PRINCETON PARK JSP17-10 with Rezoning 18.717

PRINCETON PARK JSP 17-10 AND ZONING MAP AMENDMENT 18.717

Public hearing at the request of Pulte Homes of Michigan, LLC for Planning Commission's Recommendation to City Council for a Planned Rezoning Overlay associated with a Zoning Map amendment, from OS-1 (Office Service) to RM-2 (High Density Multi-Family Residential). The subject property is approximately 24-acre and is located on the west of Novi Road and north of Ten Mile Road in Section 22. The applicant is proposing a development of 125-unit multi-family attached condominiums with frontage and access to Novi Road

PLANNING REVIEW

Figure 1. City of Novi Regulated Wetland & Woodland Map (approximate project area is highlighted in red). Regulated Woodland areas are shown in green and regulated Wetland areas are shown in blue).

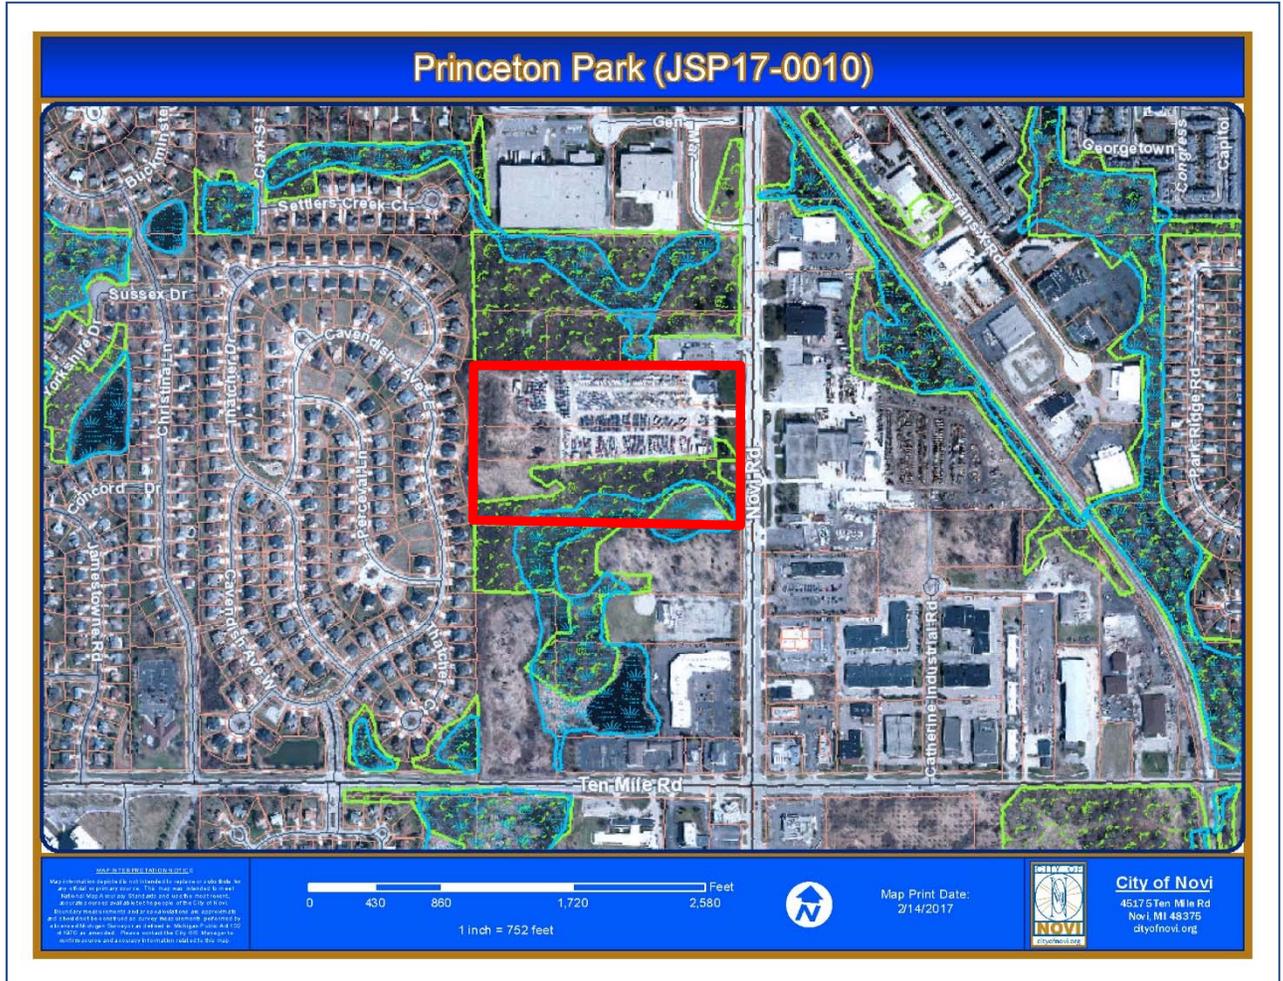
Based on our review of the Plan, Novi aerial photos, Novi GIS, the City of Novi Official Wetlands and Woodlands Maps (see Figure 1, attached) it appears as if this proposed project site contains City-regulated wetlands and woodlands. The City's wetland and woodland map shows that the overall property contains wetlands to the south. However, a review of aerial photos of the site and the proposed site plan, the site contains three (3) areas of wetland (Wetlands #1, #2, and #3), along both the southern and western portion of the site.

As noted, three (3) areas of wetland exist on this parcel (Wetland #1, #2, and #3). The proposed site development appears to be partly designed around the existing on-site wetland and 25-foot wetland setback areas. The *Layout Plan* (Sheet 05) indicates that the proposed development will impact Wetland #3 and the storm water outlet is currently planned to be directed to the 25-foot setback of Wetland #1, in the southeast portion of the site. The following table summarizes the existing wetlands and the proposed wetland impacts as shown on the Plan:

Figure 1. City of Novi Regulated Wetland & Woodland Map (approximate project area is highlighted in red). Regulated Woodland areas are shown in green and regulated Wetland areas are shown in blue).

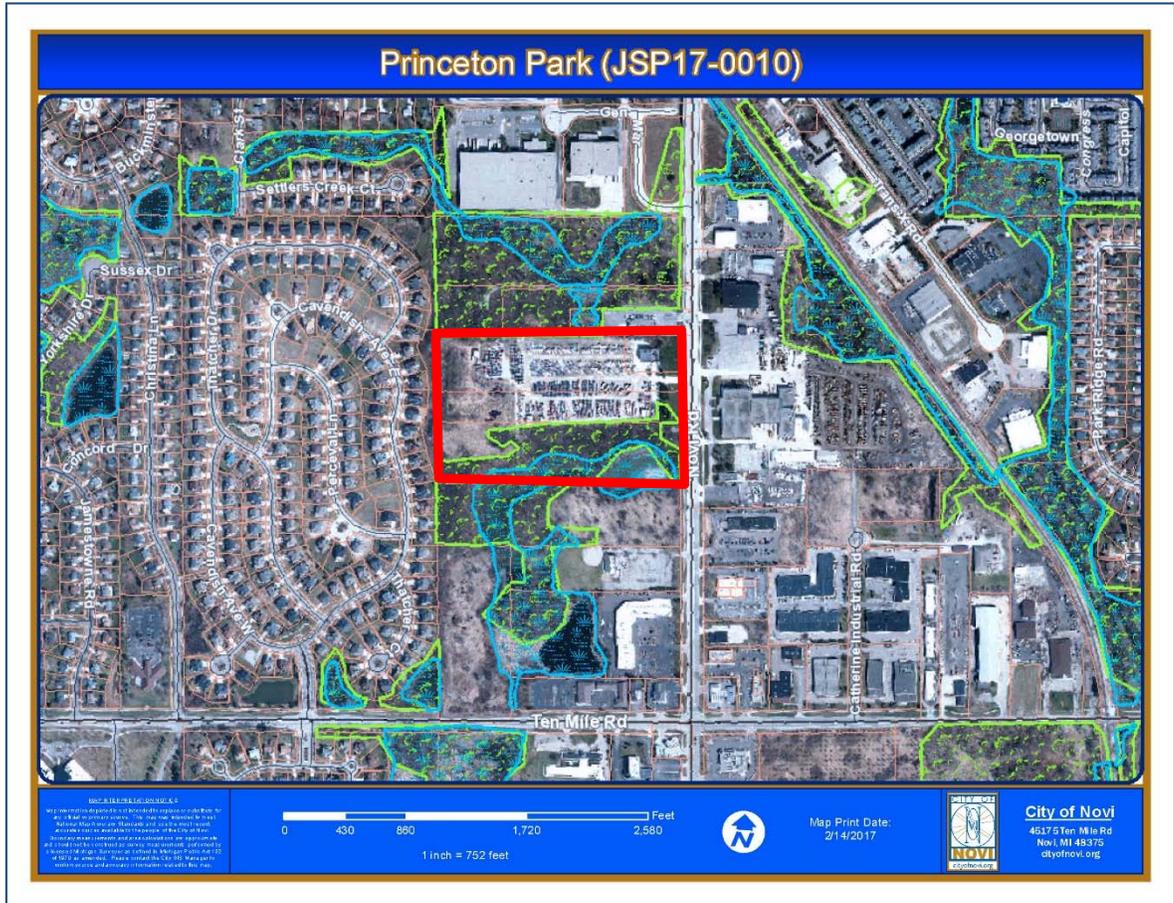
ECT completed an on-site woodland evaluation on Tuesday, February 21, 2017. As noted above, the site does contain area designated as City of Novi Regulated Woodland. A significant portion of the proposed limits of disturbance for the project is located outside of the areas mapped as City Regulated woodland (see Figure 1). The

majority of the Regulated Woodland area is located on the southern portion of the project site (see Figure 1). Tree survey information has been provided on the *Tree List* plan (Sheet 03). This sheet includes a tree list that indicates the proposed woodland impacts and required Woodland Replacement tree credits for these removals. The Plan indicates that a total of 328 trees have been surveyed for the project. Of the trees surveyed, 262 trees are located within the area designated as Regulated Woodland (80% of the surveyed trees are located within the regulated woodland area). Fifty percent (50%) of the surveyed trees are comprised of the following tree species:
